HONOR CHARTER SCHOOL

HONOR CHARTER SCHOOL BUILDING CORPORATION
8250 Bent Grass Meadows Drive, Peyton, Colorado 80831
Owner Project No. 3225193
AGENCY NUMBER: AHCA-123456.78

ELECTRICAL
SITE PLAN

V1_Lighting Plan.pdf Markup Summary

ELECTRICAL SITE PLAN
1" = 30'-0"

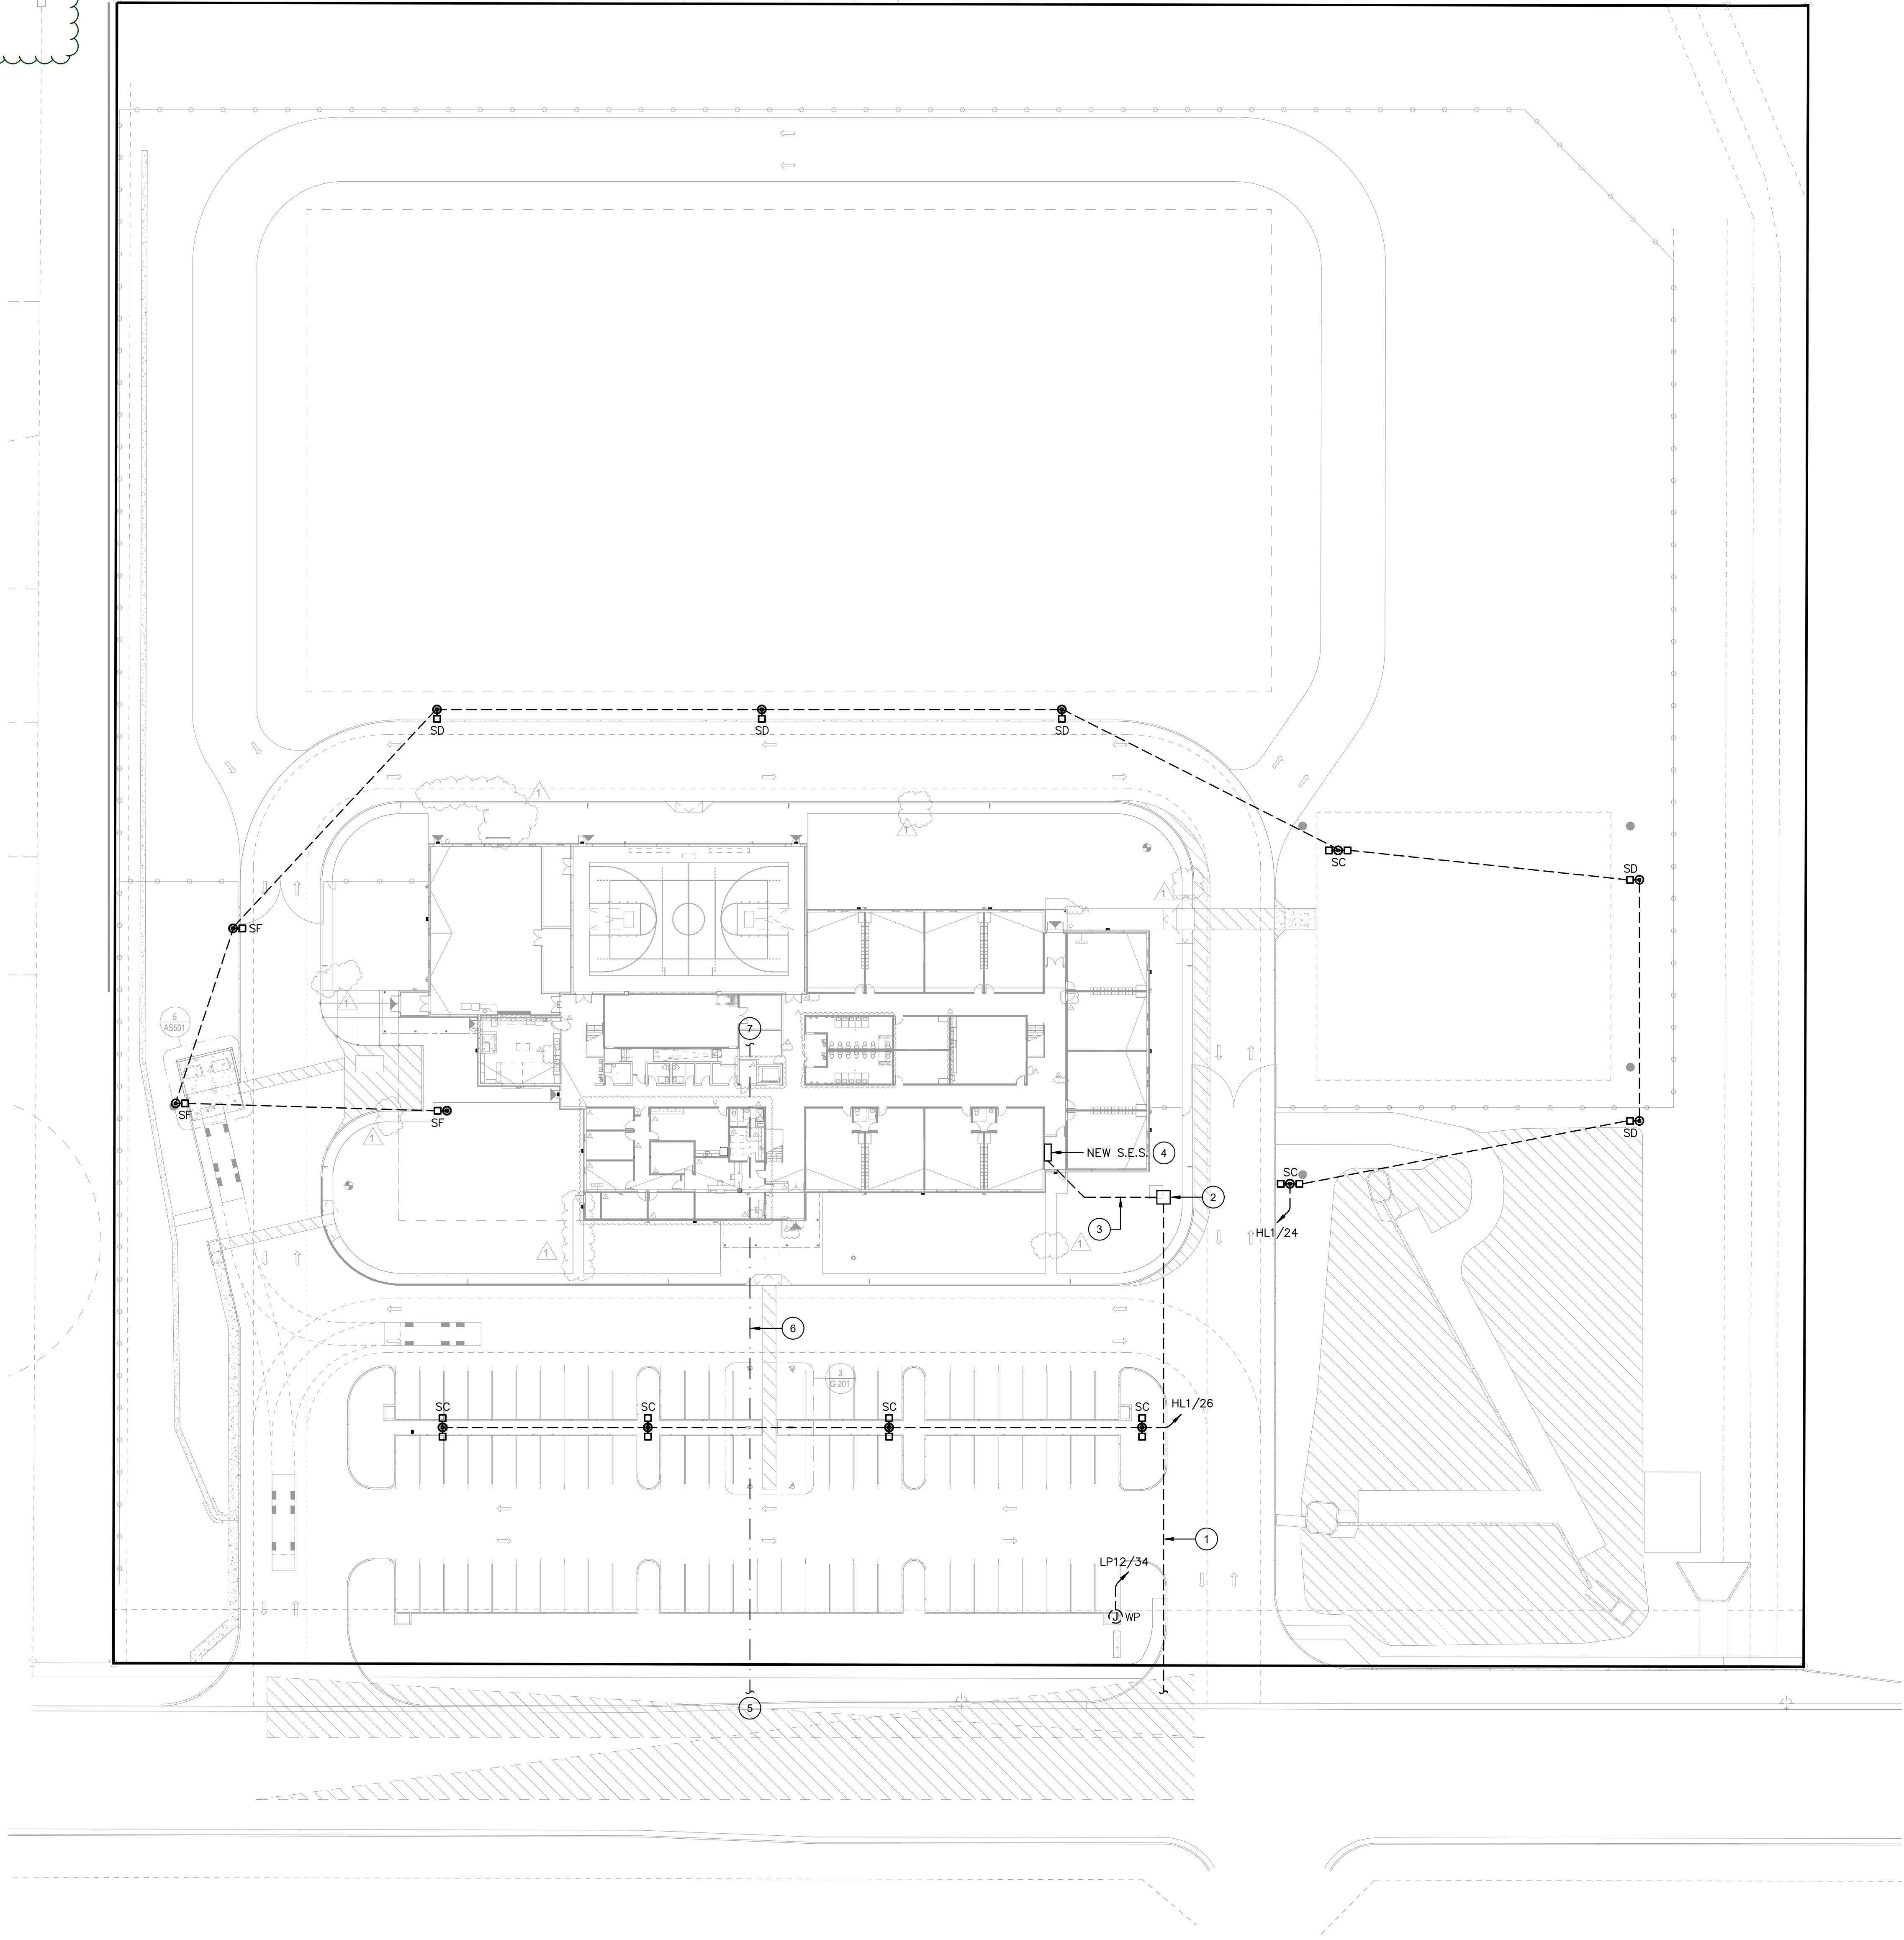
identify hours, height,
cut off etc see Land
Development Code,
section 6.2.3

identify hours, height, cut off etc see Land
Development Code, section 6.2.3

SHUT OFF SCHEDULE IS DESIGNED TO COMPLY WITH THE
ABOVE. SHUT OFF SCHEDULE "NOTE L" HAS BEEN ADDED
TO GENERAL NOTES/ REF SHEET ES-111.

SHUT OFF SCHEDULE IS DESIGNED TO COMPLY WITH THE ABOVE. SHUT OFF SCHEDULE "NOTE L" HAS BEEN ADDED TO GENERAL NOTES/ REF SHEET ES-111.

SITE
PHOTOMETRIC
PLAN

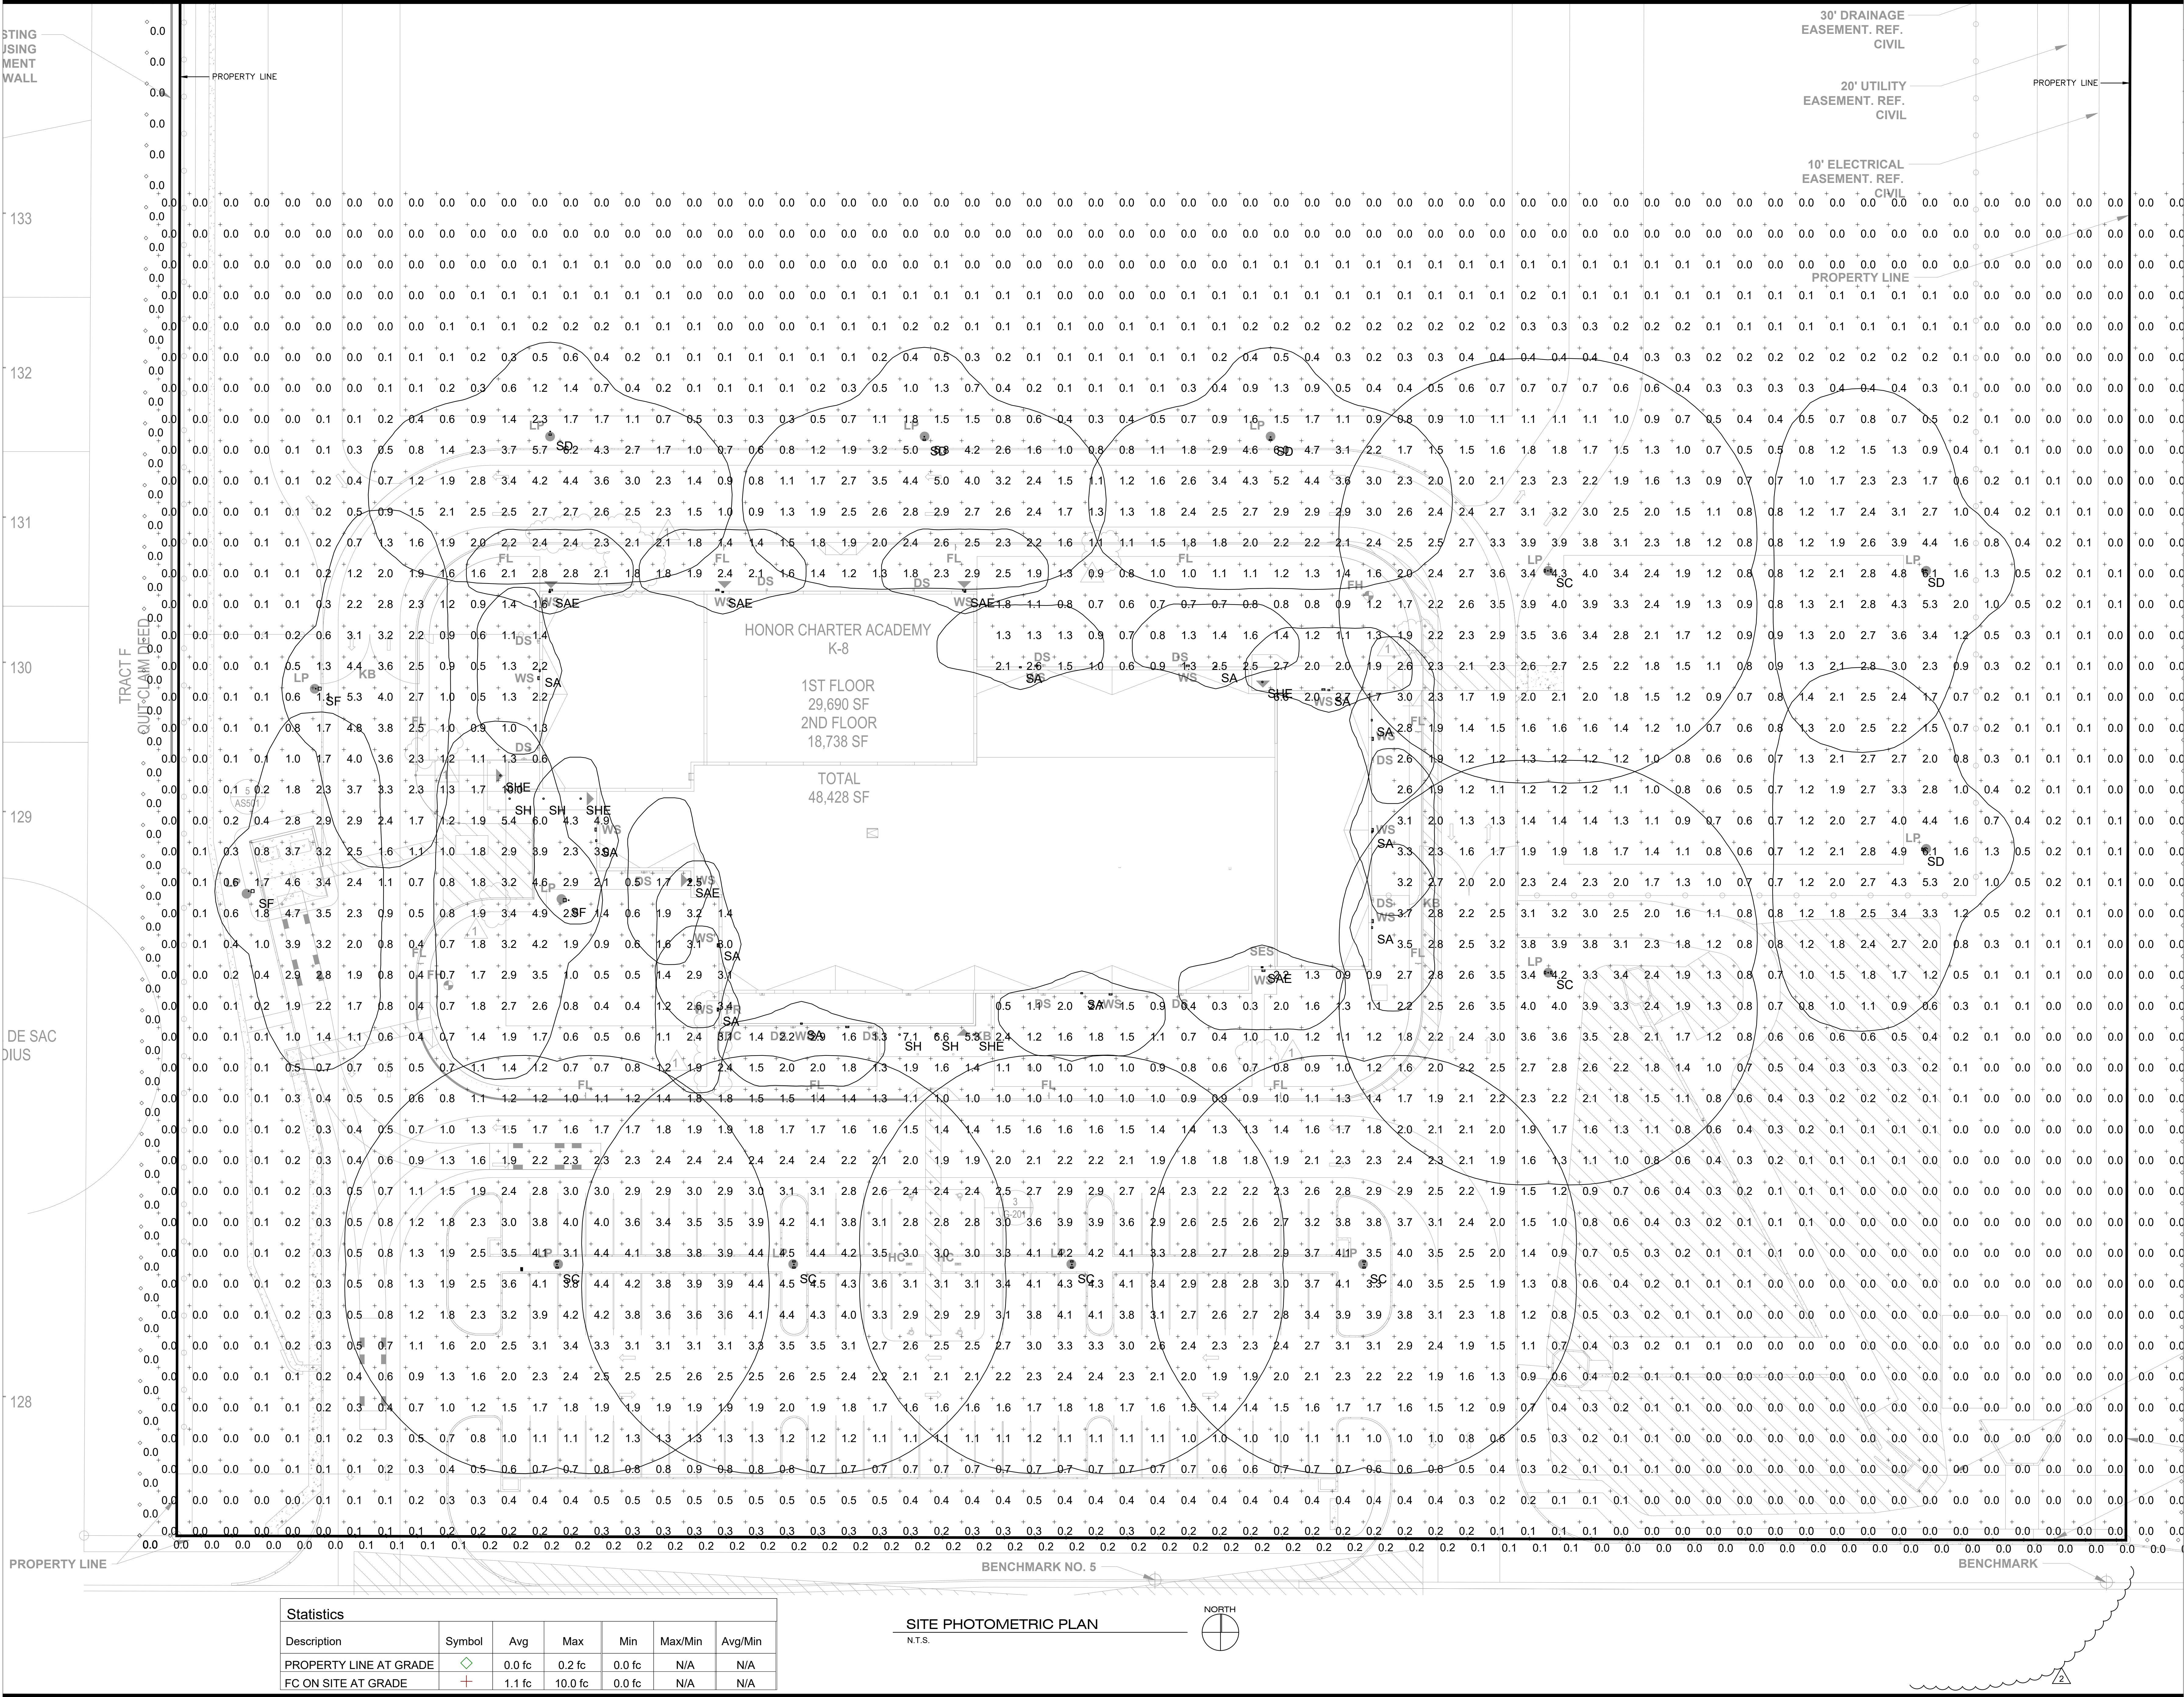
Add property lines and verify full cut off fixtures and provide height of pole mounts. Please see lighting standards in Code

is this sign electric and does it change messages?
provide lumens at property lines

Is this what you are proposing to reduce impacts to residents?

PROPERTY LINES HAVE BEEN IDENTIFIED

1 & 2. DESIGN INTENT IS TO PROVIDE POWER FOR FUTURE SCHOOL SIGNAGE BY OTHERS/ SIGNAGE IS PROPOSED TO BE BACKLIT STATIC SCHOOL NAME AND LOGO

3 & 4. "HOUSE SIDE SHEILDS" HAVE BEEN SPECIFIED AT LIGHT POLES TO REDUCE POTENTIAL GLARE INTO RESIDENTIAL AREAS/ REF SHEET ES-113 FOR CUT SHEETS.

TREES/ LANDSCAPE BUFFERS ARE ALSO PROVIDED AT THE SOUTH PROPERTY LINE TO REDUCE POTENTIAL LIGHT POLUTION.

SECONDARY OPTION "EXTERNAL GLARE SHIELD" IS PROVIDED, SHOULD EPC REQUIRE MORE THAN SPECIFIED.

CONFIRMED/ ALL LUMINAIRES ARE FULL CUT OFF. REF SHEET ES-112.

ALL LIGHT LEVELS ARE BELOW 0.1 AT PROPERTY LINES. NO LIGHT FIXTURES ARE WITHIN 15' OF ADJACENT PROPERTY LINES. "HOUSE SIDE SHIELDS" ARE SPECIFIED.
